CONTRACT NO. DE-AC27-01RV14136 – TRANSMITTAL OF U.S. DEPARTMENT OF ENERGY, OFFICE OF RIVER PROTECTION (ORP) DESIGN OVERSIGHT REPORT NUMBER D-06-DESIGN-027: REVIEW OF BECHTEL NATIONAL, INC.'S (BNI) RADIOCHEMICAL ANALYTICAL LABORATORY PNEUMATIC AUTOSAMPLING SYSTEM (ASX) DESIGN

**REVIEW BECHTEL NATIONAL, INC.
RADIOCHEMICAL ANALYTICAL LABORATORY
PNEUMATIC AUTOSAMPLING SYSTEM DESIGN**

DESIGN OVERSIGHT: D-06-DESIGN-027

Figure 4-1. ISOLOK[®] Diagram for Liquid and Slurries

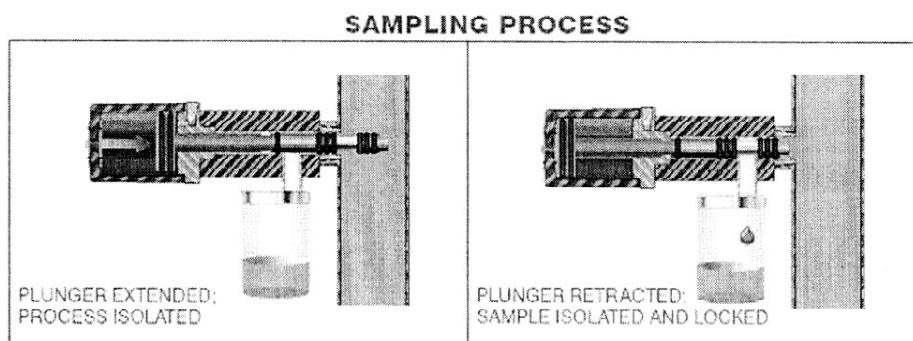
- b. ISOLOK[®] (Autosampler) Design: BNI raised concerns throughout last year's weekly ASX subcontractor meetings regarding whether the ISOLOK[®] as designed (off-the-shelf) will obtain a representative sample of the waste upon each sampling effort. Bristol/Sentry's ISOLOK[®] test in 2005 was inconclusive with respect to whether non-Newtonian process waste samples (containing solids) would leave residue trapped at the "line adaptor" (interface between the pipe and sampler). Bristol/Sentry's modeling only consisted of the ISOLOK[®] /sampling components. BNI is scheduling an accuracy and performance test consisting of a large prototypic-scaled system that includes a prototypic vessel, mechanical agitator, transfer pump, recirculation pump, and horizontal piping that directly supplies liquid/slurry to the ISOLOK[®] and the ISOLOK[®] mechanism. This test will be conducted at Catholic University of America (CUA) in Washington, DC. D-06-Design-027-AFI-02 identifies the re-evaluation of the ISOLOK testing.

Figure 4-2. Autosampling System Overview
(Diagrammatic Sketch)

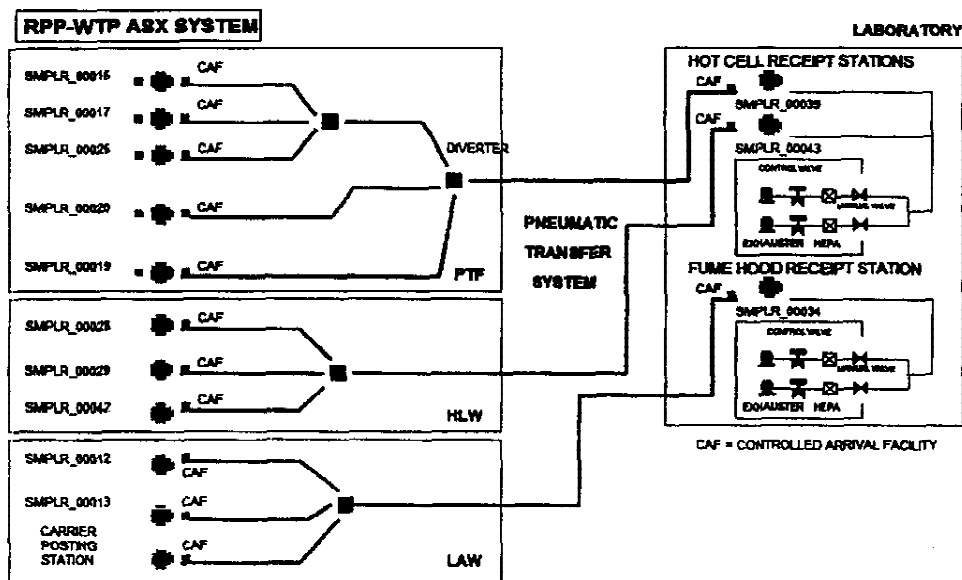
- a. Pneumatic Piping System: The piping is designed "Normal Fluid Service" as designated by American Society of Mechanical Engineers (ASME) B31.3, *Process Piping*, and is rated for air service under vacuum and atmospheric pressure conditions only. PTS maximum internal design pressure is 14.7 pounds per square inch absolute (psia) and minimum design pressure is 10.3 psia. Both stainless steel (SS) and PVC PTS piping will be Schedule 40 and have a nominal 3-in outside diameter, and 3.068-in inside diameter with a piping wall thickness of 0.216-in.

- Pipe Bend Radius (integral to ASX gloveboxes and receipt stations): The carriers are commercial grade quality. The bottles are APC quality to provide confinement of sample materials in the hotcells. The length of sample carriers is 7.5-in with an outside diameter of 2.878-in. The Design Oversight Team determined from performing a basic geometric modeling calculation, as well as reviewing ASX lessons learned from THORP and INL, that a large centerline pipe-bending-radius is required to provide uninhibited carrier transfer through the PTS. By incorporating lessons learned from THORP, BNI is designing the PTS pipe, outside the autosampling envelope, with a 48-in. minimum centerline pipe bend-radius. However, PTS piping integral to the autosampling envelope and receipt stations are subcontractor designed with a 20-in. centerline pipe bend-radius in an area where carrier speed is reduced. BNI is currently investigating the functionality of allowing subcontractor designed piping with a 20-in. centerline piping bend-radius. As stated above in paragraph 4.1.a, there are unresolved RAM calculation comments related to BNI's acceptance of the subcontractor's 20-in. pipe bends integral to the autosampling envelope. These BNI's submittal comments that were formally sent to the subcontractor will be resolved once the ASX Contract resumes. D-06-Design-027-AFI-01.e identifies the re-evaluation of the ASX bend radius for piping integral to the gloveboxes and receipt stations.

- a. The THORP system has PVC piping similar to the transfer piping design for the Waste Treatment Plant. THORP originally used a relatively sharp centerline pipe bend radius of 24-in. which was changed, during operations, to 48-in. Before THORP began using a larger centerline bend radius, pipe abrasion from the carriers and cracking within the piping system occurred. Approximately six cracks per year occurred. THORP used the following two mitigation strategies: (1) replacing the piping with larger radius bends and (2) hardening bends with thicker or additional PVC. INL also experienced carrier and sharp bend radius issues, which were modified by incorporating larger bending radii. In addition, INL experienced breakage of carriers at the docking units, which was solved by creating an air pocket in front and back of the carrier. The WTP ASX design and the THORP design include control arrival facilities/equipment that significantly decreases the speed of the sample carrier upon arrival at the docking units.

- Retrieval of Stuck or Broken Bottle/Carrier within PTS: The Design Oversight Team identified the following areas of concern: (1) Details of the process in which a portable exhaustor will be used to pull a stuck carrier, close to the sampler, within the PTS back
